MAPLE SHADE ADDITION

RE: SUB 2000-55 -- Final Plat of Maple Shade Addition

RE: SUB 2000-55 -- Final Plat of Maple Shade Addition

CASE NUMBER: SUB 2000-55 -- MAPLE SHADE ADDITION

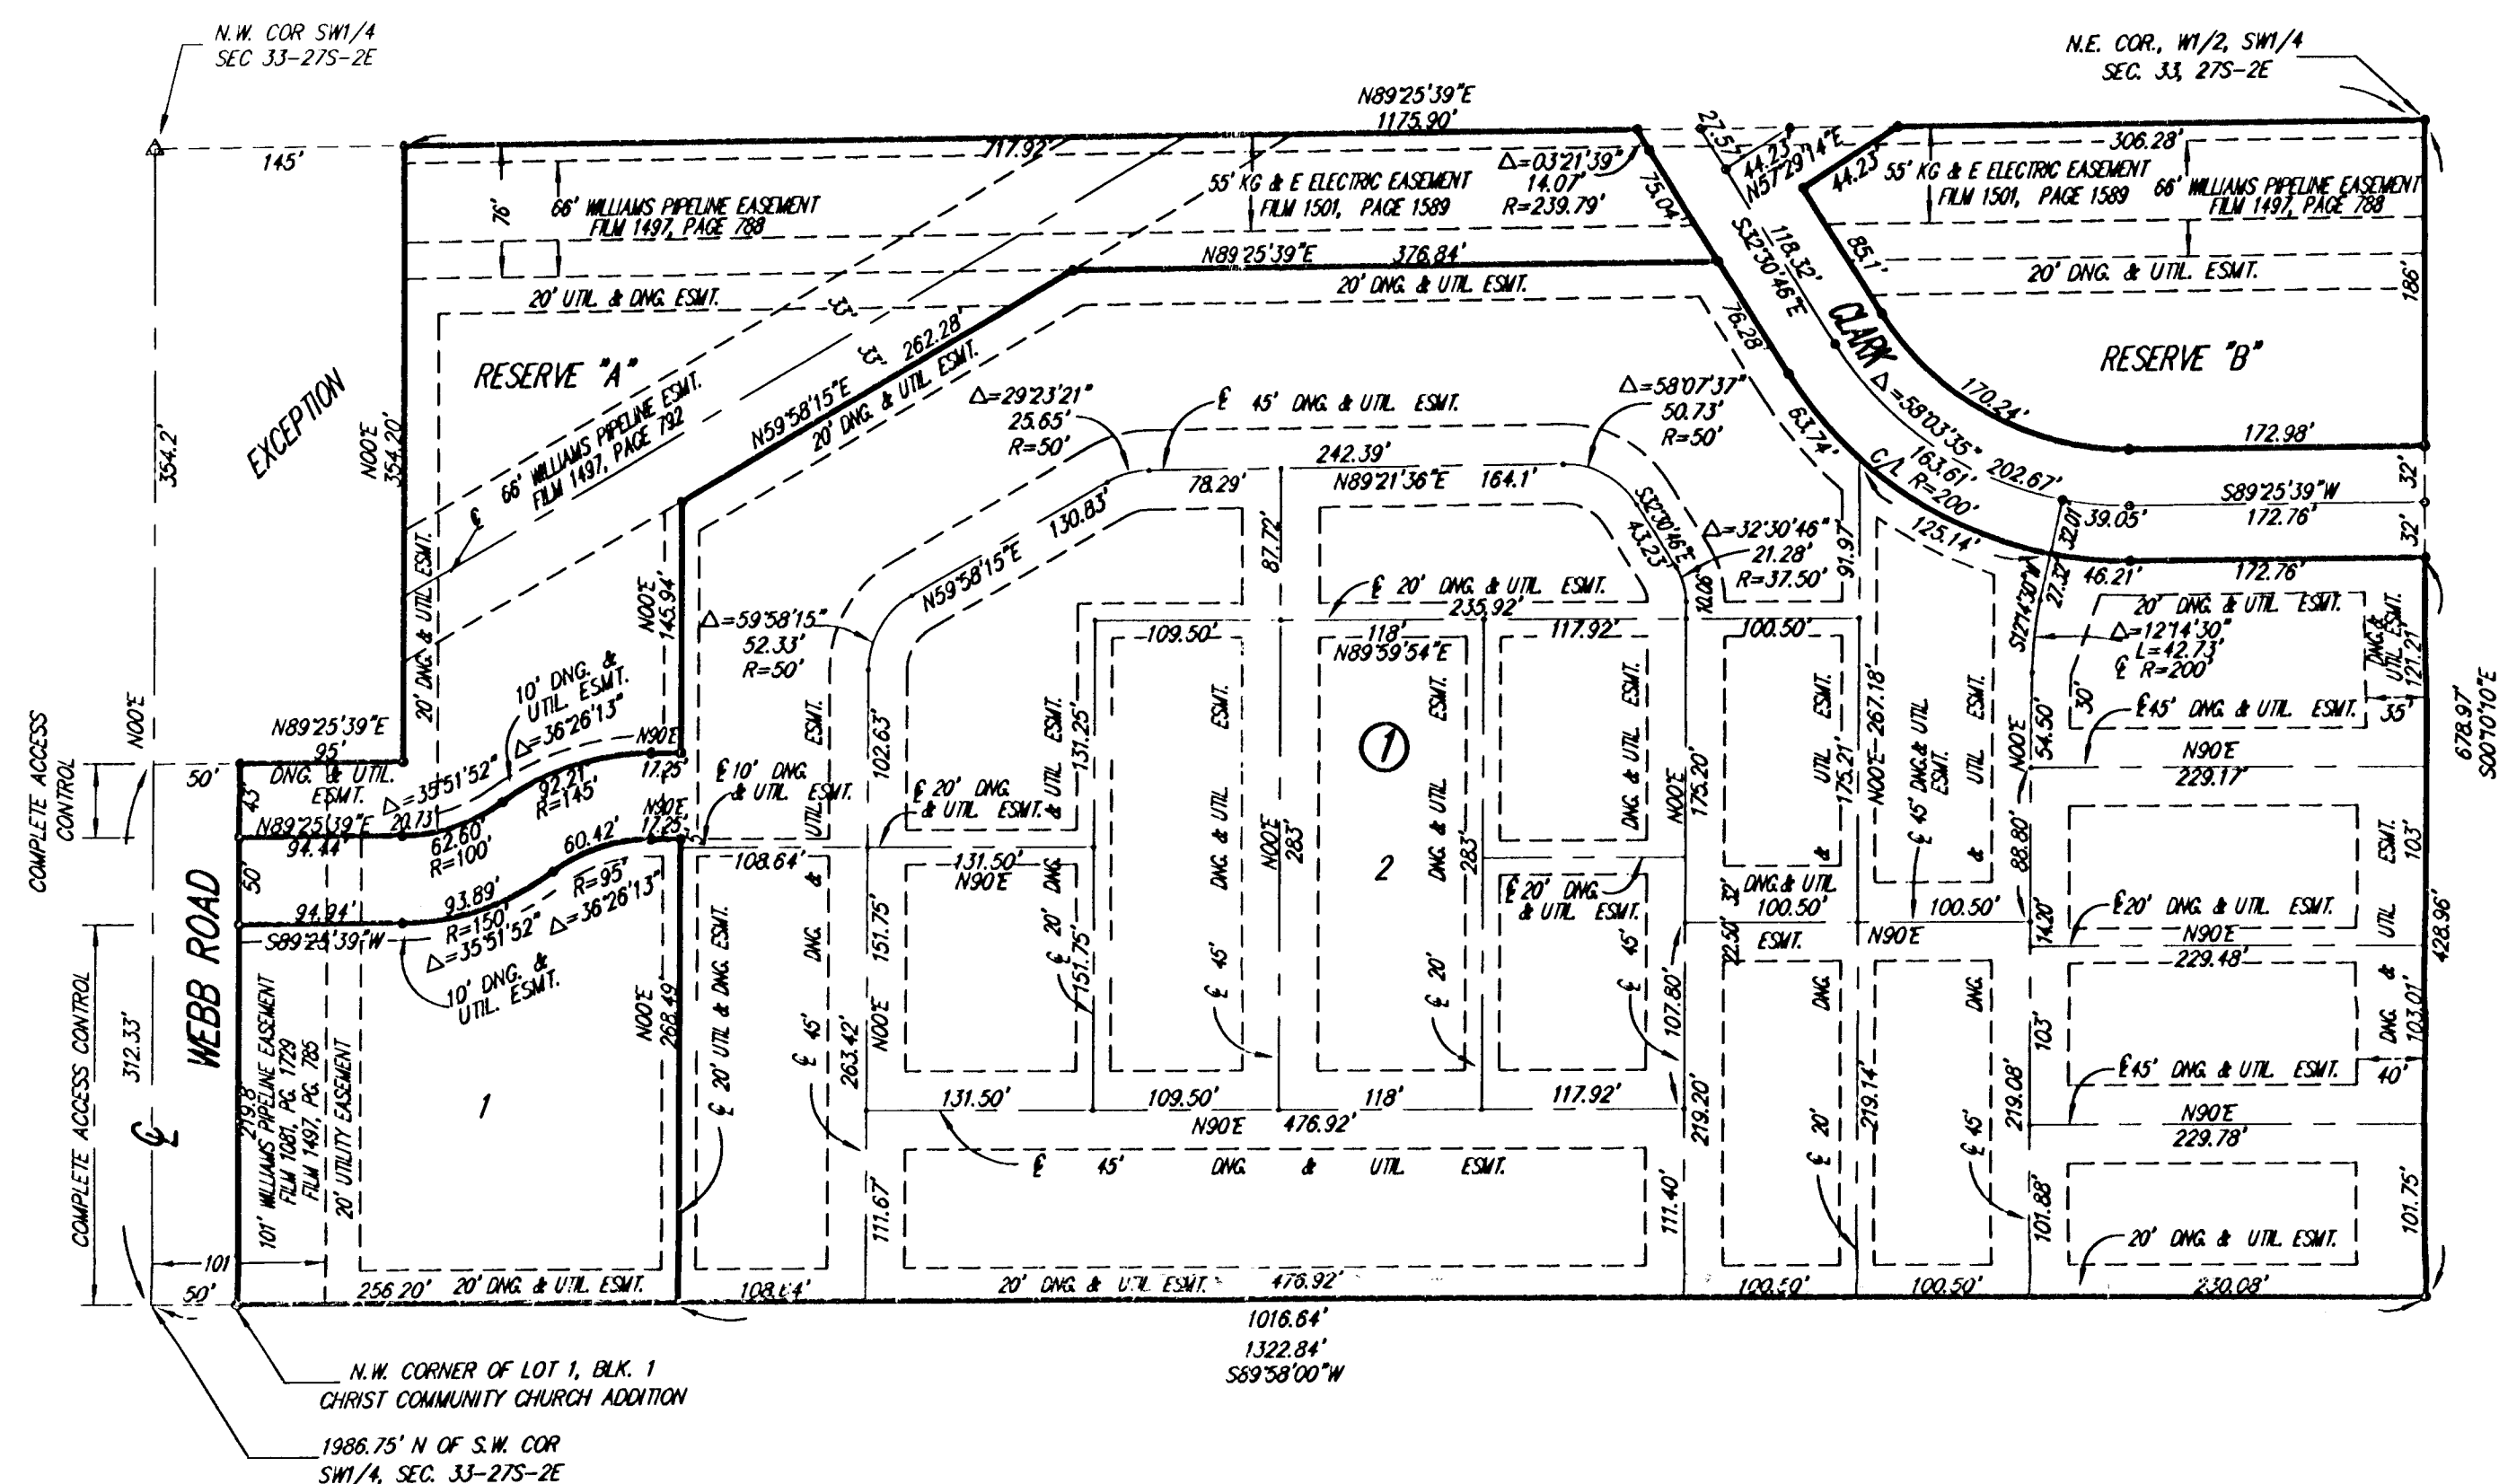
- A. As this site is adjacent to Wichita's City limits, the Applicant shall submit a request for annexation. Prior to this plat being scheduled for City Council review, annexation of the site will need to be completed.

- B. This plat will be subject to approval of the associated zone change and any related conditions of such a zone change.
- C. The applicant shall guarantee the extension of sanitary sewer to serve the lots being platted. This guarantee shall be with the City for service through the Four Mile Creek sanitary sewer system. County Engineering requests a sanitary sewer layout.

- D. The applicant shall guarantee the extension of City water to serve this site.
- E. If improvements are guaranteed by petition, a notarized certificate listing the petitions shall be submitted to the Planning Department for recording.

- F. City Engineering needs to comment on the need for any additional guarantees or easements. An off-site drainage easement is requested unless this Addition is platted concurrently with Brentwood South Addition to the east. A drainage guarantee is required.

- G. City Engineering needs to comment on the status of the applicant's drainage plan. On-site detention will be needed on the final drainage plan.
- H. The plat's text shall include ownership and maintenance responsibilities of the reserves.

- M. The applicant shall submit a copy of the instrument which establishes the pipeline easements on the property, which verifies that the easements shown are sufficient and that utilities may be located adjacent to and within the easements.

- N. The applicant's agent shall determine any setback requirements for the pipelines by researching the text of the pipeline agreements. If a setback from the pipeline easements is provided for in the pipeline easement agreements, it shall be indicated on the face of the plat.

- O. The Applicant shall guarantee the paving of the proposed streets. The guarantee shall also provide for sidewalks on the south side of Clark.
- P. The paving guarantee shall include the installation of a temporary turnaround at the terminus of Clark at the plat's east line unless the abutting street to the east has been constructed. The temporary turnaround shall be established by separate instrument.

- Q. City Fire Department should comment on the plat's street names. Stoneybrook should be revised to "Clark".

The street name has been revised as requested.
- R. A Protective Overlay Certificate shall be submitted to MAPD prior to City Council consideration, identifying the approved Protective Overlay (referenced as P-O #83) and its special conditions for development on this property.
- S. The plat's text shall include language that a drainage plan has been developed for the plat and that all drainage easements, rights-of-way, or reserves shall remain at established grades or as modified with the approval of the applicable City or County Engineer, and unobstructed to allow for the conveyance of stormwater.
